Amendment Report  
Sydney Olympic Park new high school  
SSD-11802230

On behalf of  
NSW Department of Education  
June 2022

This Amendment Report has been prepared by Mecone NSW Pty Limited on behalf of the NSW Department of Education (DoE) to support the proposed Sydney Olympic Park new high school (SSD-11802230).

**Figure 1** Updated site plan (based on roof plan)  
Source: Woods Bagot

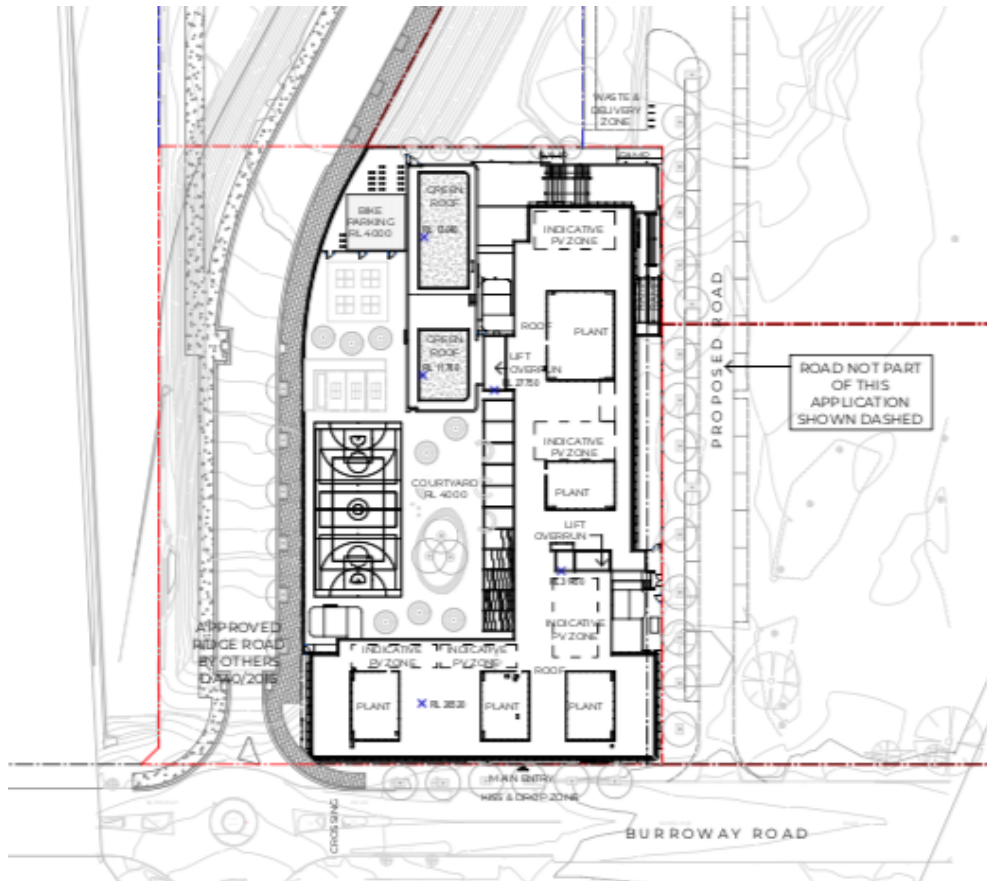
It is proposed to remove all school development from the approved Ridge Road reserve, which cuts diagonally across the site. This will ensure Ridge Road can be constructed as approved under consent DA 40-2015 (as amended), if necessary.

Removal of development from the approved road reserve requires several changes to the school design, namely:

- Reduction in size of the 2-storey hall building including removal of indoor sports court;
- Reconfiguration of central courtyard;
- Removal of an outdoor sports court; and
- Bicycle parking moved to rear of site and quantity reduced from 258 to 146 to reflect the proposed cap of 850 students.

An updated site plan is provided below. For further detail, refer to the updated architectural, landscape and civil drawings at **Appendix 1**, **Appendix 2** and **Appendix 3a**, respectively.
